Environmental Impact Statement

Accelerator Production of Tritium at the Savannah River Site

Final
March 1999

TITLE: Final Environmental Impact Statement: Accelerator Production of Tritium at the Savannah River Site (DOE/EIS-0270)

Figure 1-3. NEPA documentation for related DOE actions.

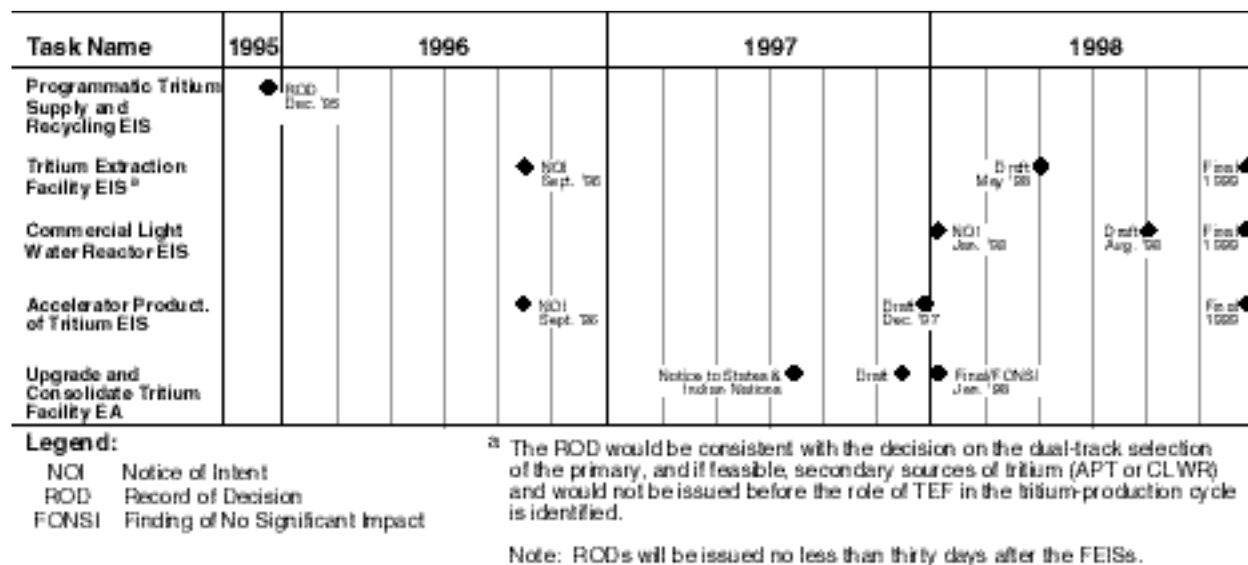
[Chapter 1, Section 1.5 modification to the Draft APT EIS]

DOE has also issued a draft EIS (DOE/EIS-0288D) which analyzes the impacts of using an existing or partially built commercial light-water reactor to produce tritium. DOE proposes to make one or more Record(s) of Decision based on that EIS. The upgrade and consolidation of tritium facilities was evaluated in an environmental assessment followed by a Finding of No Significant Impact. The key milestones and status of each of these documents is presented in Figure 1-3.

DOE-SR APT EIS/F15011/APT_AbrDGm_C75-1410.rpt
Figure 3-4. Land forms, topography, and 100-year floodplain of the preferred and alternate sites. The footprint of the modular design variation is superimposed over the baseline APT footprint at each site.

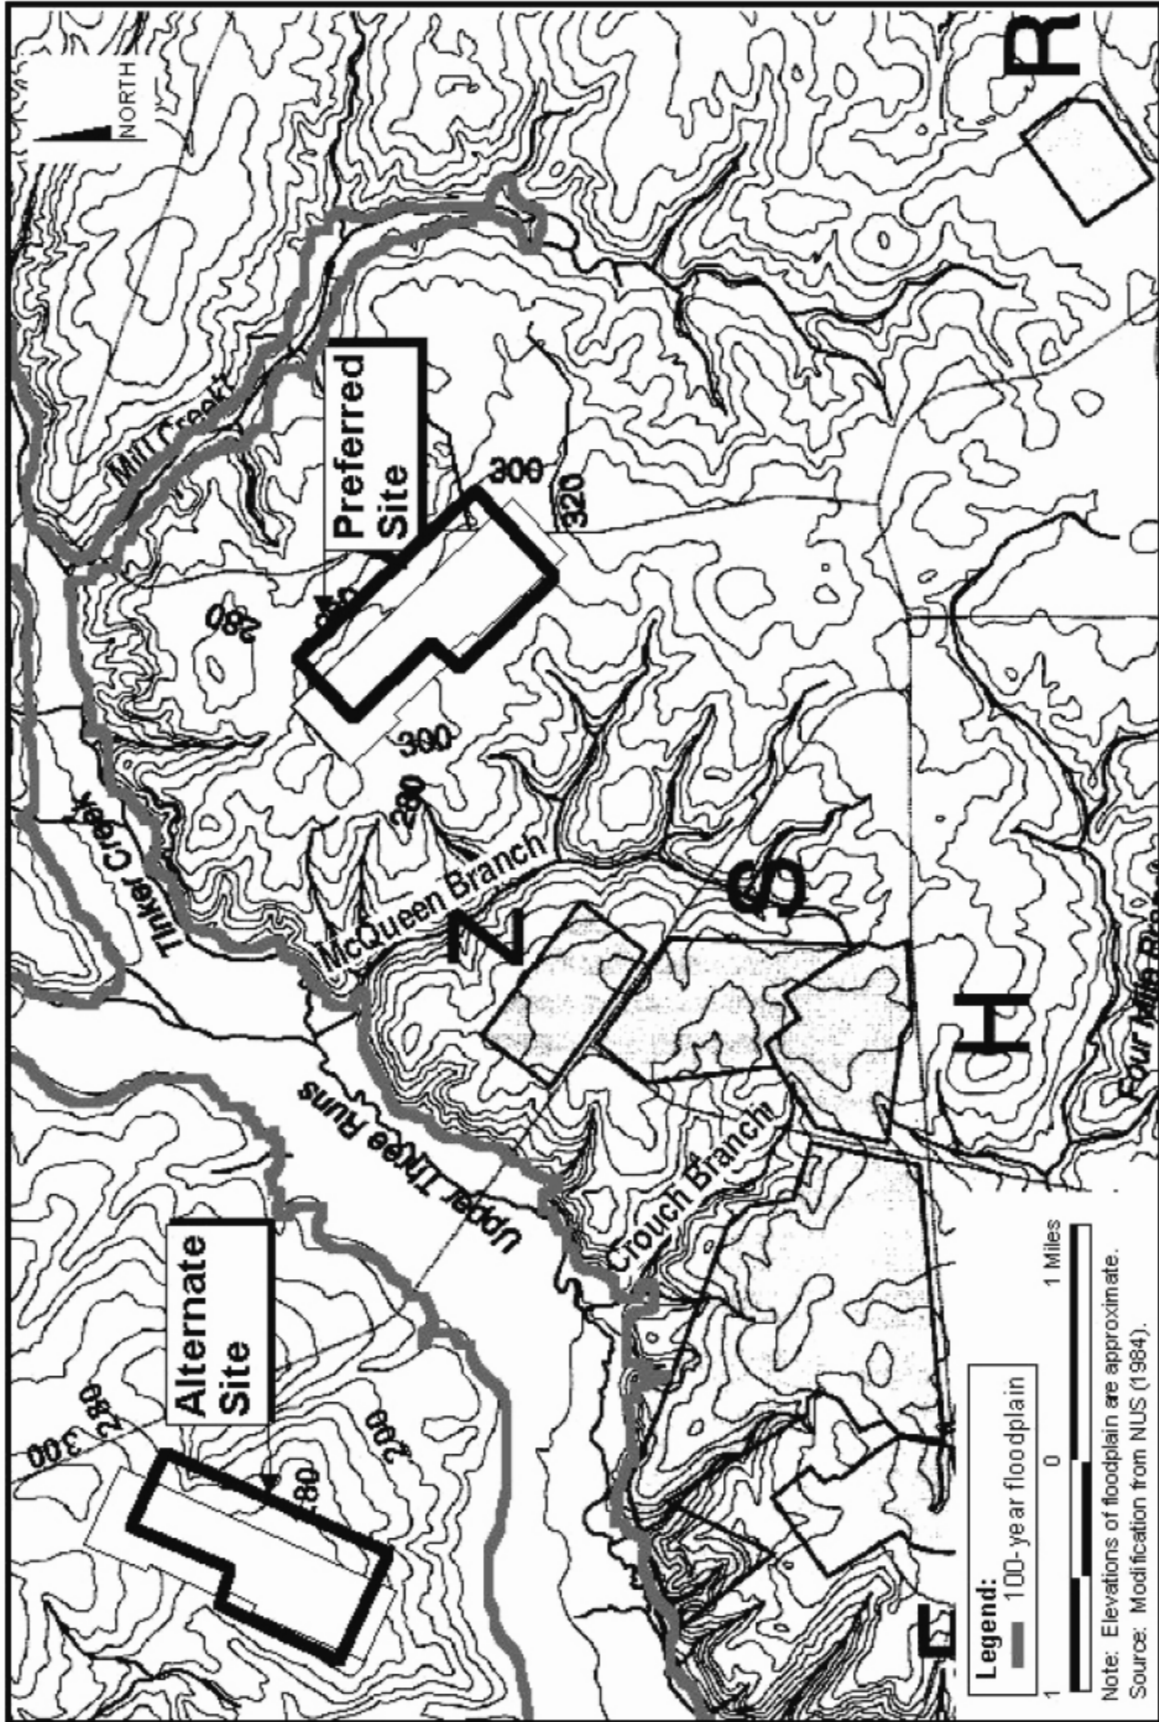
The modular or staged accelerator design variation would result in a small modification of the APT footprint. The overall area would be slightly less than that of the baseline accelerator. Text changes have been made in Section 3.3.1.1, 3.3.1.2, and 3.4.2. Figures 3-4, 3-5, 3-5a, 3-16, and 3-17 and Table 3-1 have been revised to show the modular footprint and its relationship to the footprint for the baseline design.

Page 3-6, 1st column, 3rd paragraph and Figure 3-4 on page 3-7 are replaced by the following:

Both the preferred and alternate APT sites are on relatively flat, broad and sandy upland areas typical of the Aiken Plateau portion of the Savannah River Site that formed in deep beds of marine sediments (Wike et al. 1994). The orientation of the APT footprint on the preferred site is from southeast to northwest; the footprint orientation on the alternate site from southwest to northeast. Figure 3-4 shows the locations of the sites and their surface features (topography and nearby surface waters). **The footprint variation for the modular or staged accelerator design is also shown. As can be seen, the modular design variation would result in a**

Figure 3-5. Soil types at the preferred APT site.

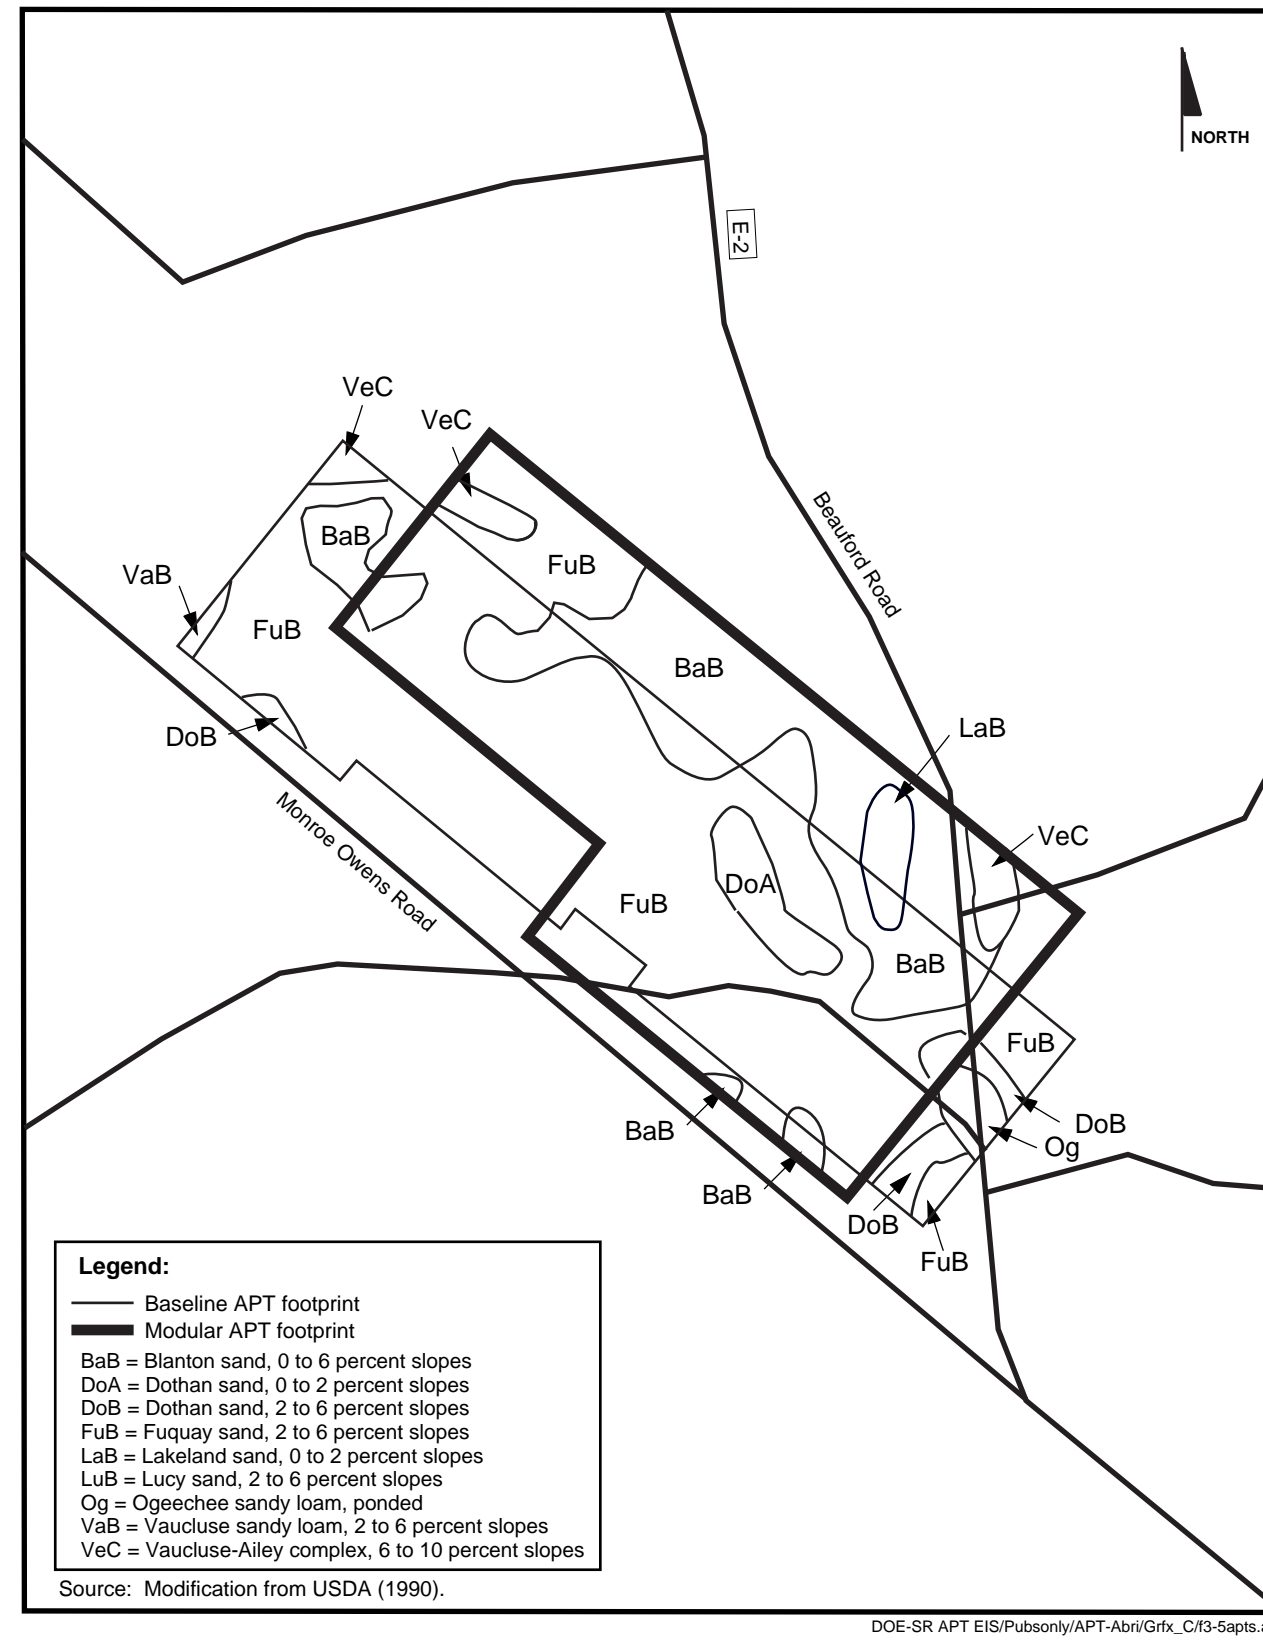
Page 3-8, 1st Column, 1st paragraph, 5th through 9th lines, Figure 3-5 on page 3-9, and Table 3-1 on page 3-10 are replaced with the following:

Figure 3-5 and 3-5a, soil maps for the preferred and alternate sites, show the boundaries of the soil mapping units. **The footprint variation for the modular or staged accelerator design is also shown. In the case of the modular design footprint, the preferred site would have predominantly Blanton and Fuquay sands.**

Figure 3-16. Forest cover of preferred APT site.

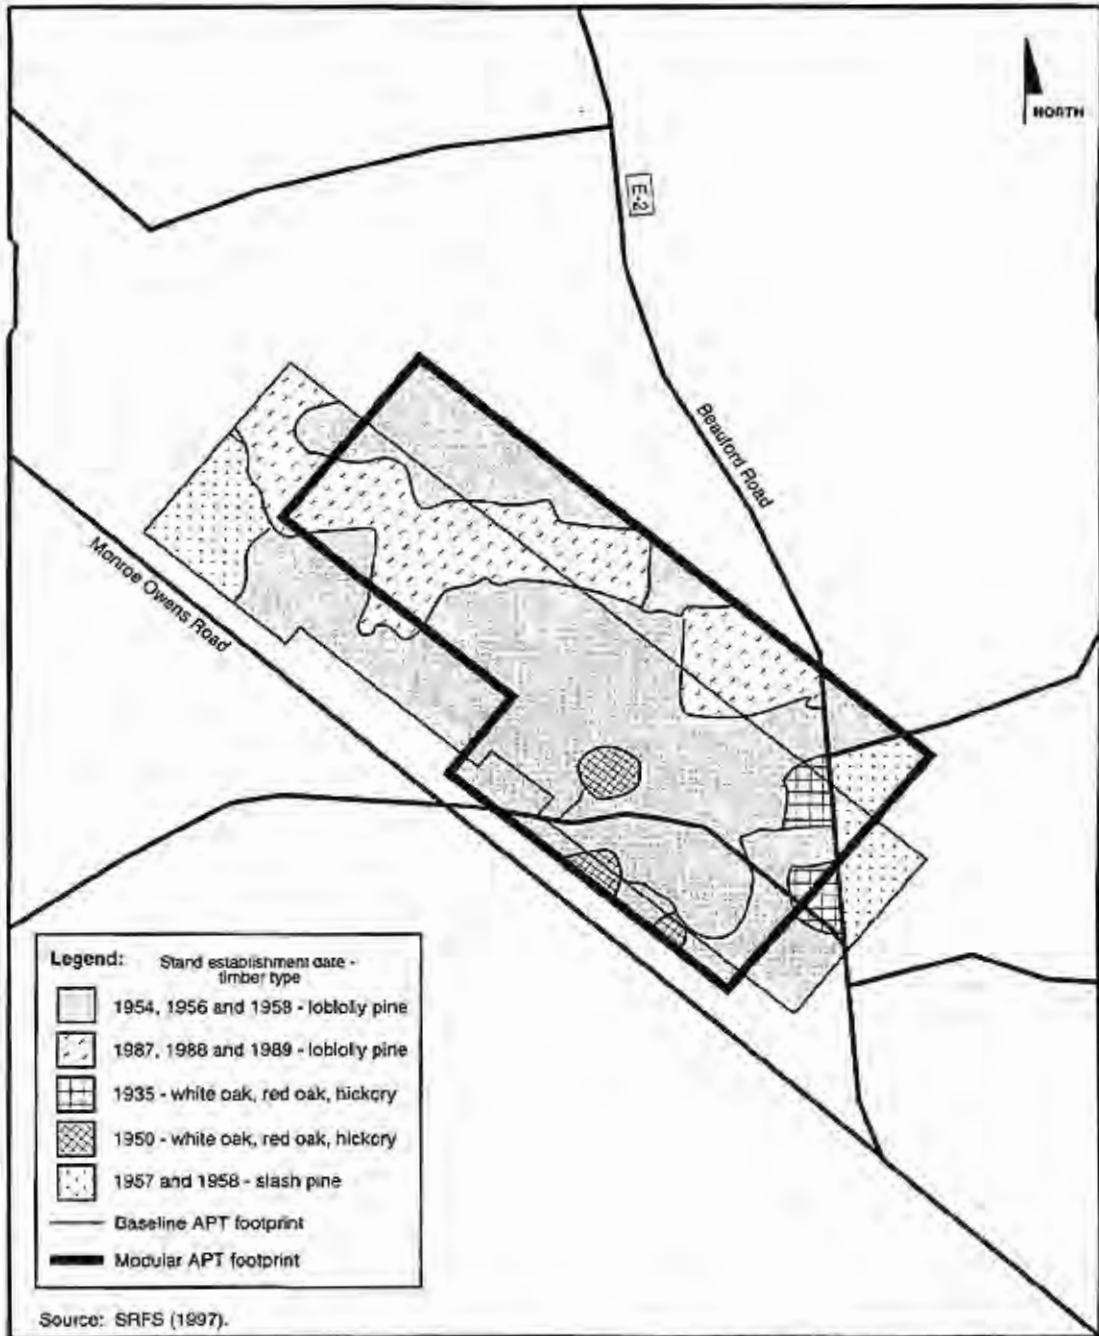
Page 3-44, 1st Column, 1st paragraph, lines 2 through 15, and Figures 3-16 and 3-17 on pages 3-47 and 3-48 are replaced with the following:

Both sites also have small pockets of 40- and 60-year old upland hardwood stands of white oak, red oak, and hickory ranging in size from 8 to 12 inches in diameter (SRFS 1997). Understory species found on the preferred site include vaciniums (blueberries), sparkleberry, hickories, laurel oak, water oak, southern red oak, sweetgum, black cherry, persimmon, sassafras, and winged sumac. Ground cover includes Japanese honeysuckle, yellow jessamine, greenbrier, muscadine grape, spotted wintergreen, various grasses, legumes, and composites (SRI 1998). Figures 3-16 and 3-17 show the forest cover types of each site. **The footprint variation for the modular or staged accelerator design is also shown. In the case of the modular design footprint, forest cover of the preferred site will be virtually the same as with the baseline footprint. On the alternate site, more acres of longleaf pine and mixed loblolly pine hardwood stands will be included in the modular design footprint.**
